NOTICE TO ALL FIRMS

Re: Addendum Number 5
IFB # C1585 – Pomerantz New Fire Alarm System

PROJECT: POMERANTZ DESIGN CENTER
FIRE ALARM SYSTEM
300 7TH AVENUE NEW YORK, NY, 10001

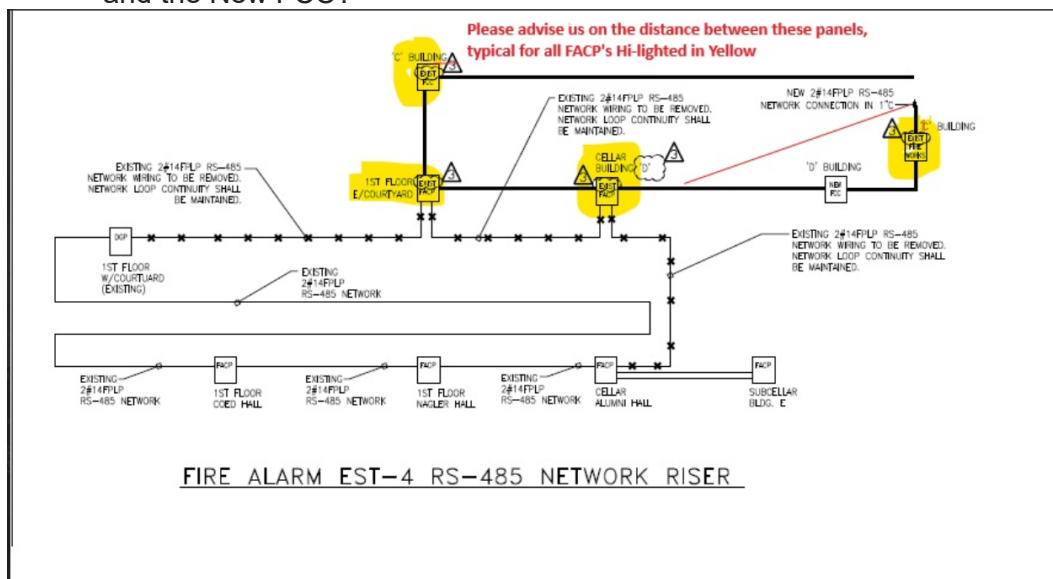
- Q1. We need some clarification on Question Q5. Your Answer A5.
The new Feldman building FCC is an EST-3 system. You are specifying an EST-4 for the Pomerantz building. No sure what panel is in Building D?
But EST-3 systems and EST-4 systems cannot operate on the same network as shown!
We asked the question if you want the EST-3 systems upgraded to EST-4? You replied they are existing.
Do you want the EST-3 panels in Feldman upgraded to EST-4?

Q4. Additional information is needed regarding the scope of work shown in the "Fire Alarm est-4 RS-485 Network Riser" diagram on Drawing FA-502.00. Are there drawings showing the current interconnectivity between the Existing FACP's in the buildings? It's nearly impossible to quantify the scope of work without as-built drawings / layout showing where the last point is in the existing loop. Please advise where each panel is located in the existing C-Building, E/Courtyard and D-Building. This will help to allocate footages associated with the completion of this work. Does FIT anticipate the drilling of any foundation walls for the routing of this conduit?

A1. Fire alarm network diagram detail on sheet E-502 is amended. The new Pomerantz Building "D" EST4 FCC will not be directly wired to existing EST3 panels. Instead, the panels on the shared network will communicate through the FireWorks system. The new EST4 Pomerantz panel must be wired to the FireWorks workstation via a CAT6 cable, now shown in the E-502 diagram existing connections from existing EST3 panels to the FireWorks workstation shall be maintained. The contractor must confirm and provide necessary components to allow for the new CAT6 connection from the new EST4 panel.

A4. The EST4 panel is being connected to the Firewoxs computer separately via CAT6 cabling. The existing system is remaining and is shown for coordination only. The software for the Firewoxs system needs to be updated to allow connectivity of both EST3 and EST 4 systems to the same computer.

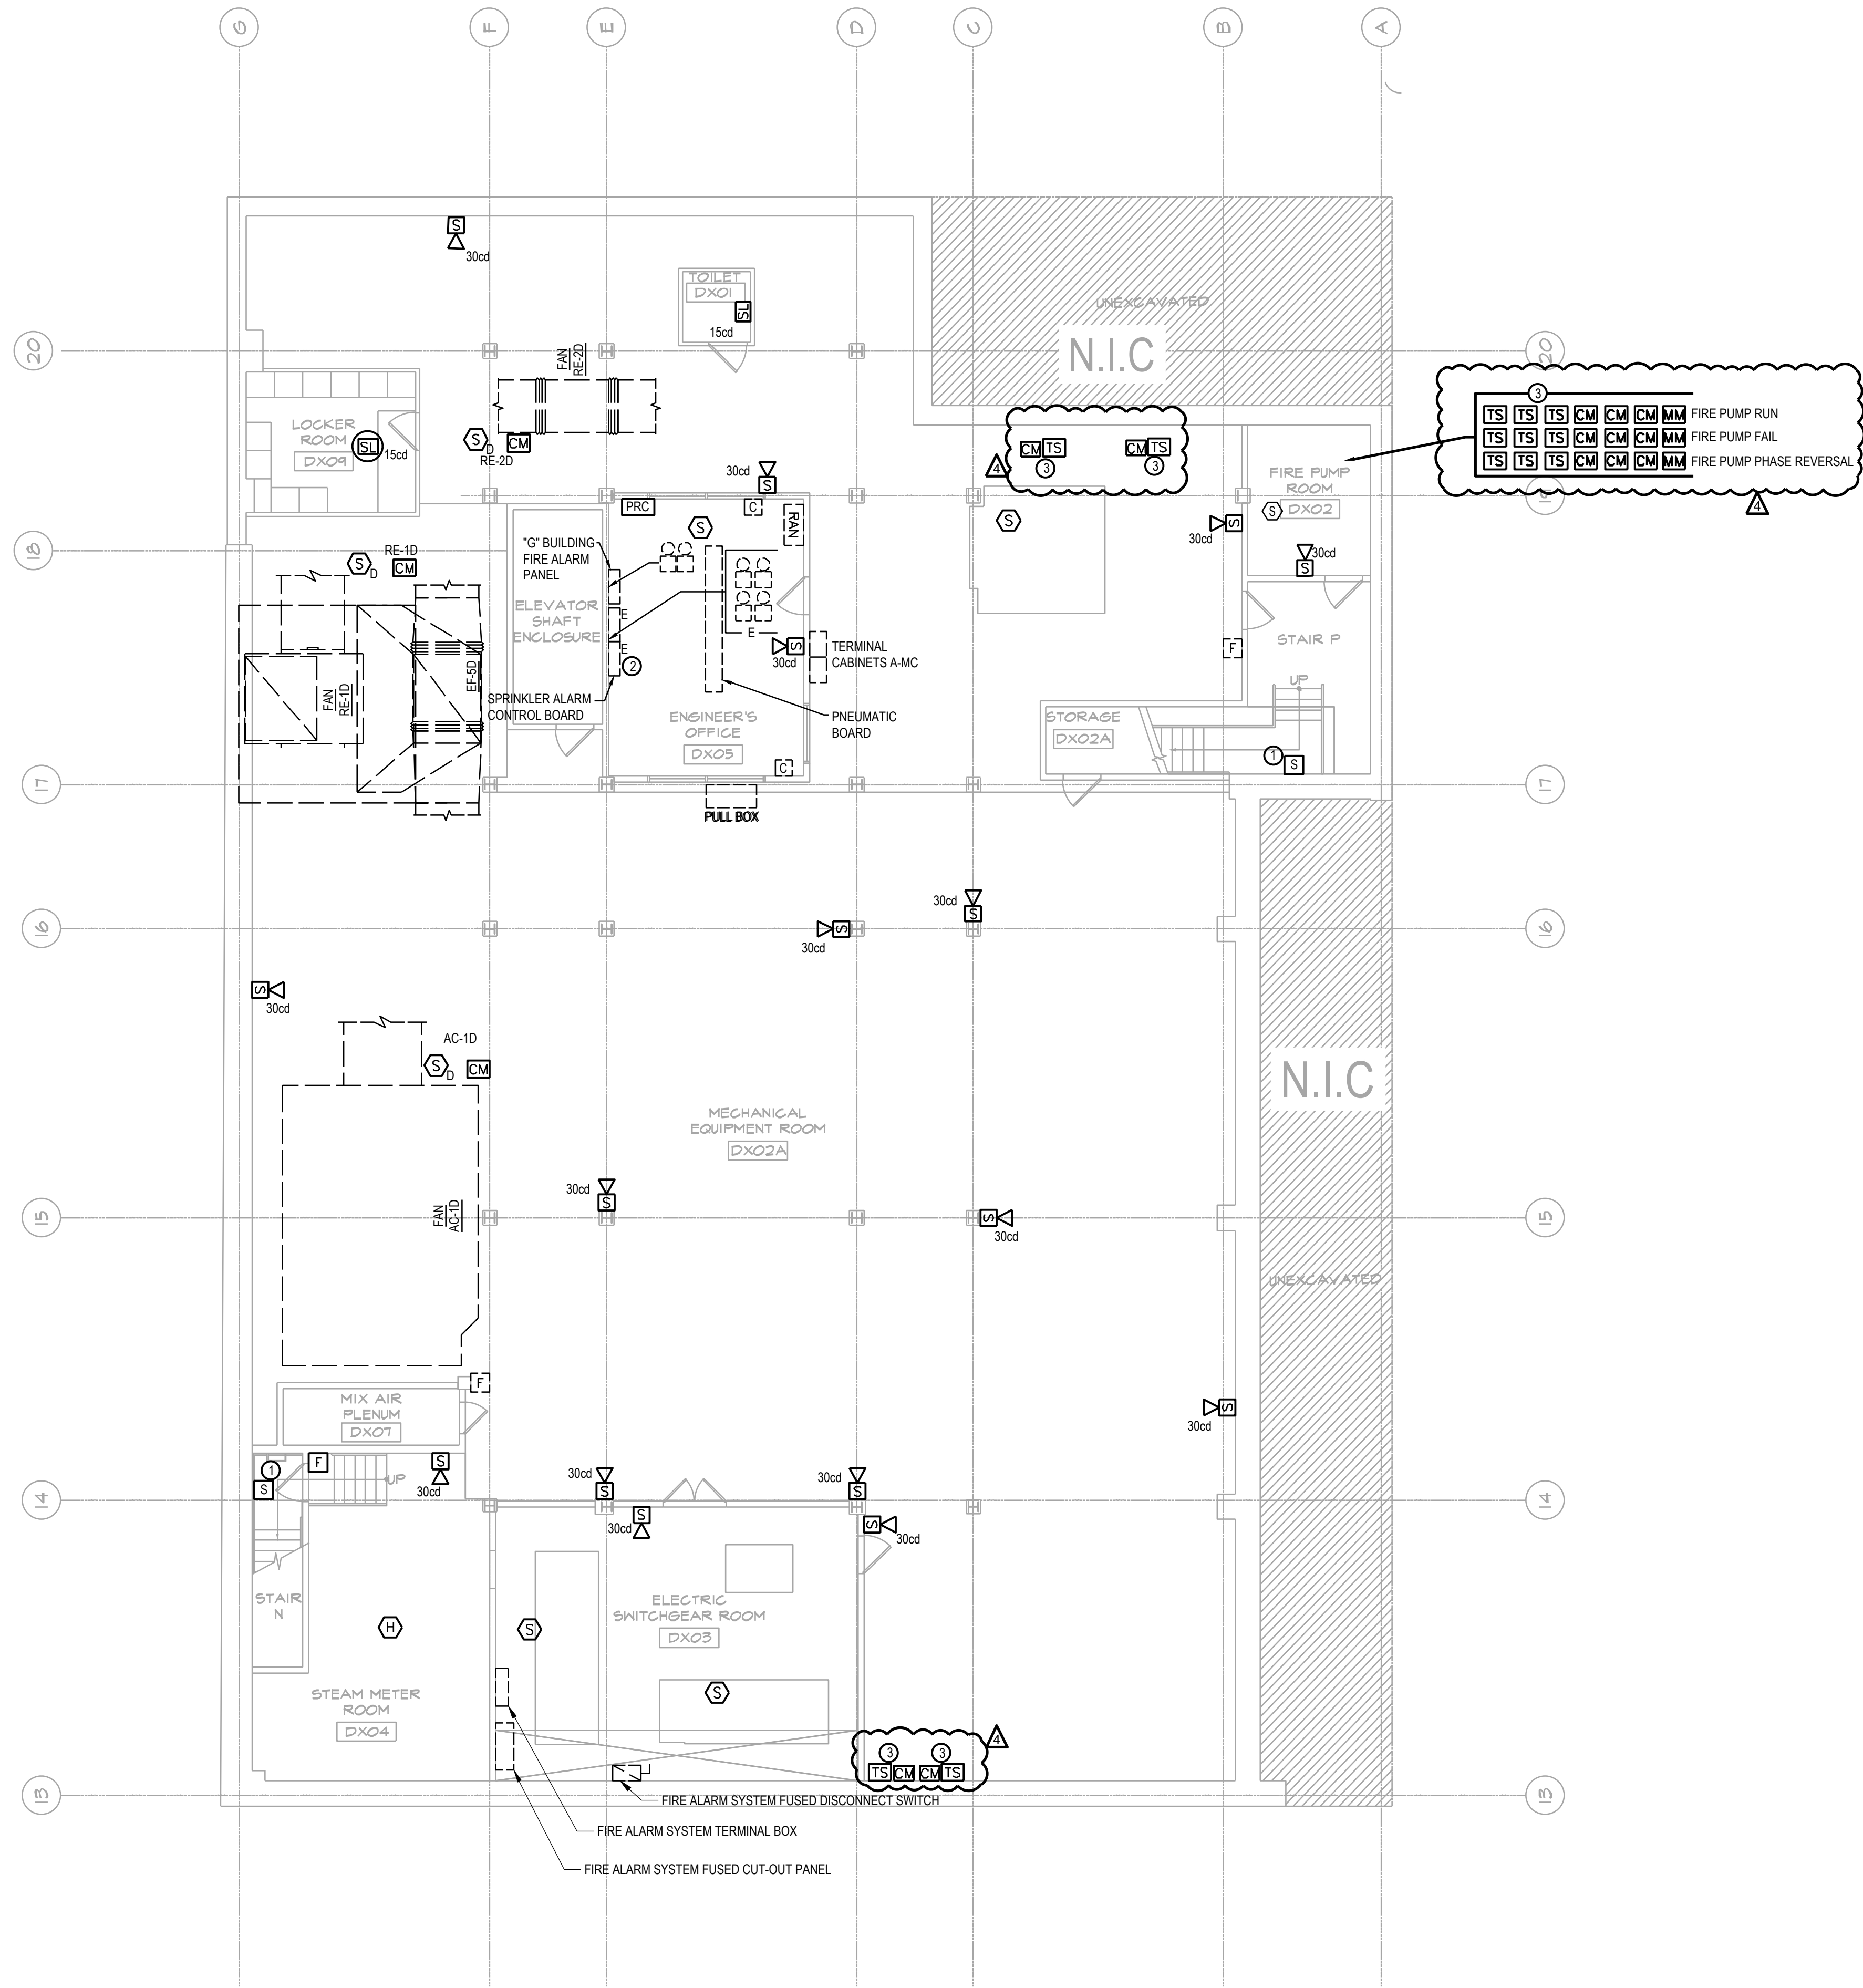
Q3. We are reviewing this project with the FA Vendor, and we would like more clarification whereas to the locations of the existing FACP's listed below so we can have a measured distance of all required cabling, and do we have to run new conduits and cabling between each of the ex. FCAP Units as per your network riser shown below or only Between the Ex. Fire Work System and the New FCC?

- A3. The required wiring is indicated by the note "new". The equipment location is already indicated on plans

SEAL & SIGNATURE:	DATE: 03.21.2025
	PROJECT No: 8969.74
	DRAWING BY: DG
	CHK BY: WM
	SCALE: 3/32" = 1'-0"
	DWG No:
	FA-099.00
CADD FILE:	DOB page: 2 OF 23

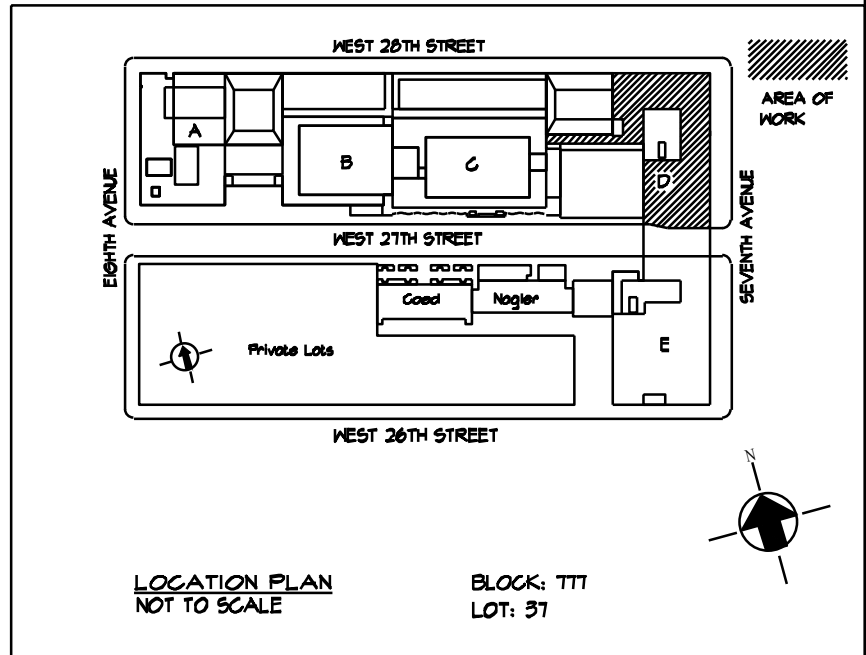
- Q2. In addendum#2 drawing FA-099 Sub-cellar Keynote states to provide addressable control module for each circuit currently controlled by Fan control relays, provide addressable control module for control of existing circuit currently operated by Master Gong Relay.

- a) Please advise us how many circuits is currently controlled by Fan control relays?
- b) There is no circuitry given for the Sprinkler Alarm control board, please advise if there is a circuitry board schedule available for this equipment?
- c) Please advise us of how many exiting circuits are currently being operated by the master Gong Relay.
- d) The fire riser drawing FA-601 does not show any wiring to or from this Sprinkler Alarm Control Board.

- A2a. There are eight (8) circuits (control modules) to be included.
- A2b. There is no circuitry required. The equipment being monitored and controlled by the monitoring modules is pneumatic actuators from and existing manifold.
- A2c. Please see answers above
- A2d. The sprinkler waterflows and tamper switches are being replaced. Notes to this effect are added to Addendum drawings accompanying these answers.
